# SERVICE TIPS

82-8

GAME: GRAND CHAMPION

FIGURE 2

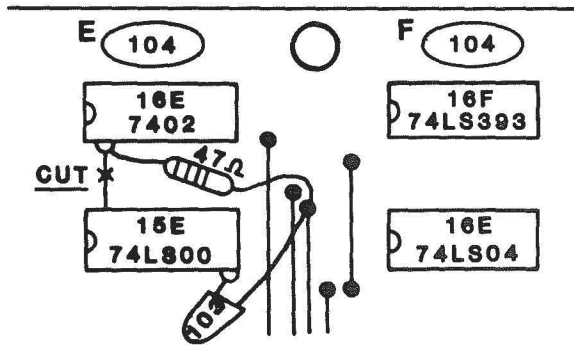
**SUBJECT:** INTERMITANT RESET

**SOLUTION:** ADD PULL-UP RESISTOR AND FILTER CAP

**PROCEDURE:** CUT ETCH COMING FROM IC E16 PIN 1 (REFER TO FIGURE 2) ADD A 47 OHM RESISTOR BETWEEN PIN 1 AND THE FEED THROUGH (REFER TO FIGURE 2) ADD THE .01  $\mu$ F CAPACITOR BETWEEN THE FEED THROUGH AND GROUND.

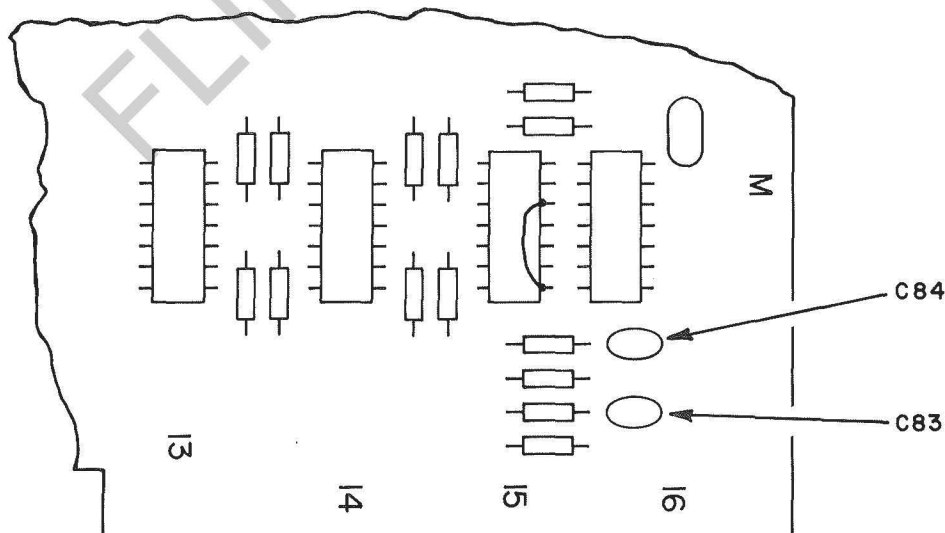
PROBLEM: COIN NOT ALWAYS REGISTERS

SOLUTION: CHANGE VALUE OF CAPACITORS FOR BETTER REACTION.

PROCEDURE: REPLACE C83 AND C84 WITH 1uf CAPACITOR (REFER TO FIGURE 1).

FIGURE 1

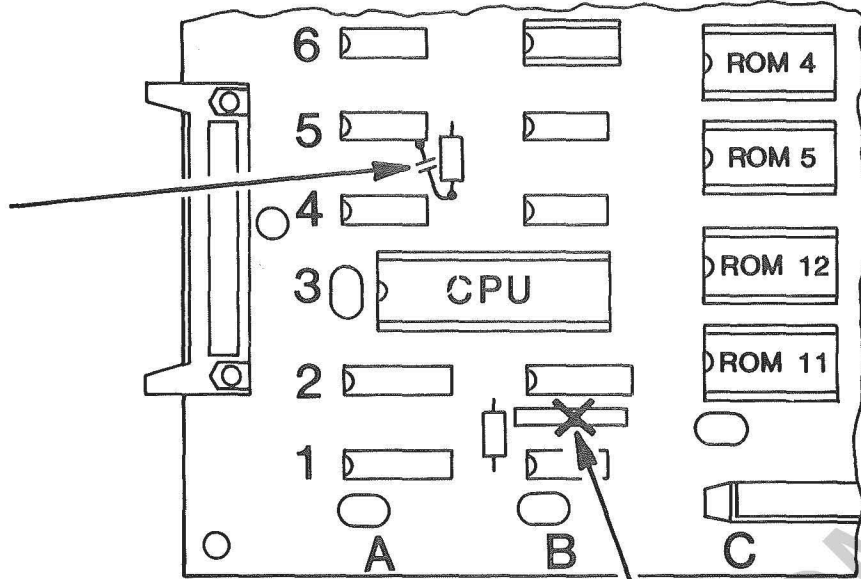
SUBJECT: INTERMITANT LOCK-UPS

SOLUTION: IMPROVE DATA LINES RESPONSE AND IMPROVE CLOCK INPUT TO BOTH CPU'S.

PROCEDURE: REMOVE THE RESISTOR BLOCK ON THE CPU BOARD LOCATED AT LOCATION 1.5B (REFER TO FIGURE 1). ADD A 330pf CAPACITOR BETWEEN THE 220 OHM RESISTOR AND GROUND AS SHOWN IN FIGURE 1.

FIGURE 1

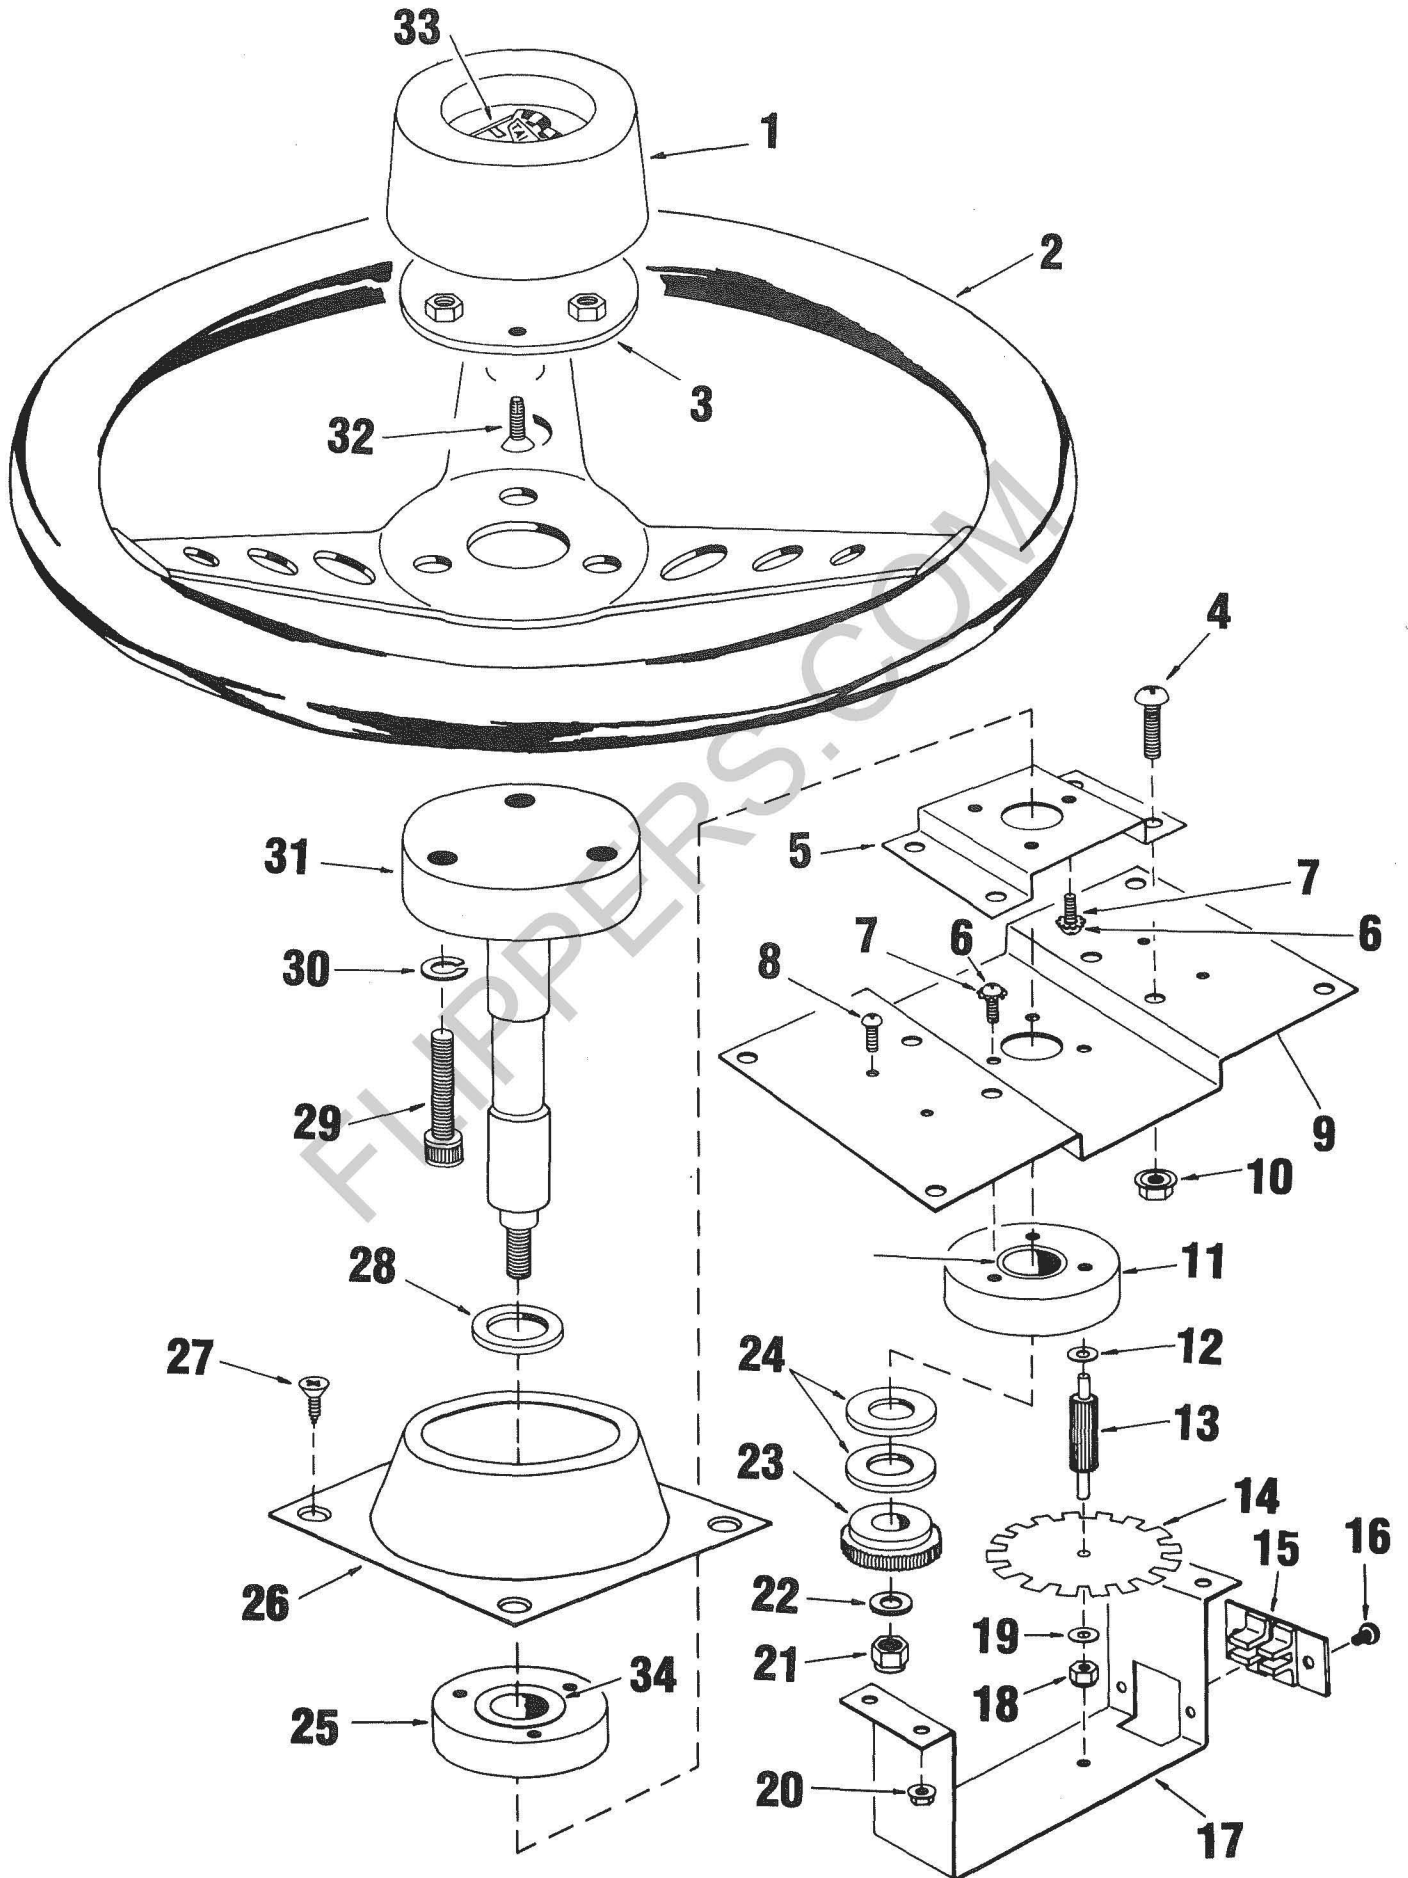
SUBJECT: STEERING WHEEL WOBBLER AFTER SOME USE.

SOLUTION: ADD SCREWS TO THE HUB (A).

IN ORDER TO DETERMINE IF THIS PROCEDURE IS NECESSARY, REMOVE THE CONTROL PANEL AND TEST TO SEE IF HUB (A) ITEM 11 IS ABLE TO MOVE IN ANY DIRECTION. IF IT DOES MOVE, THE FOLLOWING PROCEDURE NEEDS TO BE USED IN ORDER TO AVOID UNNECESSARY WEAR OF THE SHAFT.

IN ORDER TO INSTALL THE MISSING SCREWS IN HUB A YOU MUST FIRST DISCONNECT THE PHOTO SENSOR PCB PLUG AND MOVE IT OUT OF THE WAY. LOOSEN AND TAKE OFF THE FOUR FLANGE NUTS (ITEM 20) HOLDING DOWN THE SENSOR BOARD BRACKET. UPON REMOVING THE SENSOR BOARD BRACKET, THE PULSE CAM AND GEAR ( ITEMS 13 & 14) SHOULD COME LOOSE ALONG WITH IT.

LOOSEN AND REMOVE THE SELF LOCKING NUT (ITEM 21) HOLDING DOWN THE STEERING SHAFT. AFTER REMOVING THE LOCKING NUT REMOVE THE SPRING WASHER (ITEM 22), THE GEAR (ITEM 23), AND THE SPACE WASHER (ITEM 24). THE STEERING WHEEL AND SHAFT IS LOOSE NOW AND CAN BE PULLED OUT OF THE CONTROL PANEL

NEXT, REMOVE THE FOUR OUTER HUB BASE NUTS WITH THEIR ADJOINING WASHERS. ALSO, REMOVE THE EARTH GROUND STRAP CLOSEST TO THE SHIFTER. LOOSEN AND REMOVE THE FOUR FLANGE NUTS (ITEM 10) ON THE HUB BASE. NOW THE HUB BASE (ITEM 9) AND HUB A (ITEM 11), AND CAN BE REMOVED FROM THE CONTROL PANEL.

ADJOIN MISSING PAN HEAD SCREWS (ITEM 6) AND STAR WASHER (ITEM 7) TO THE HUB A. A NOTE OF CARE IS ADVISED IN ADJOINING THE HUB BASE TO THE CONTROL PANEL. THE HOLE FOR THE PULSE CAM AND GEAR SHOULD BE PUT CLOSEST TO THE GEAR SHIFTER, AS THE PLUG FOR THE PHOTO SENSOR WILL NOT REACH OTHERWISE.

WHEN REASSEMBLING THE STEERING WHEEL SHAFT TO THE CONTROL PANEL THERE MUST BE TWO SPACER WASHERS (ITEM 28) AFFIXED TO THE FRONT PART OF THE SHAFT. ON THE BACK SIDE OF THE SHAFT THERE SHOULD BE ONE SPACER WASHER (ITEM 24) AFFIXED TO THE BACK OF THE SHAFT. SOMETIMES TWO SPACE WASHERS MUST BE USED. EACH STEERING WHEEL WILL VARY DUE TO THE WEAR. IF TWO WASHERS ARE USED THE STEERING WHEEL MAY SEEM TIGHT AT FIRST, BUT LOOSENING THE SELF LOCKING NUT (ITEM 21) AN 1/8 OF A TURN AT A TIME WILL LOOSEN THE STEERING WHEEL.

WHEN ASSEMBLING THE PULSE CAM AND GEAR IN THE HOLE PROVIDED IN THE HUB A, PROPER CARE SHOULD ALSO BE TAKEN IN THAT THE PULSE CAM IS IN THE MIDDLE OF THE PHOTO SENSOR, NOT TOUCHING EITHER OF THE EDGES. THIS CAN BE DONE BY ADJUSTING THE SENSOR BOARD BRACKET (ITEM 17) AND TIGHENING THE FLANGE NUT (ITEM 20), MAKING SURE THE GEAR IS PERPENDICULAR TO HUB A (ITEM 11).
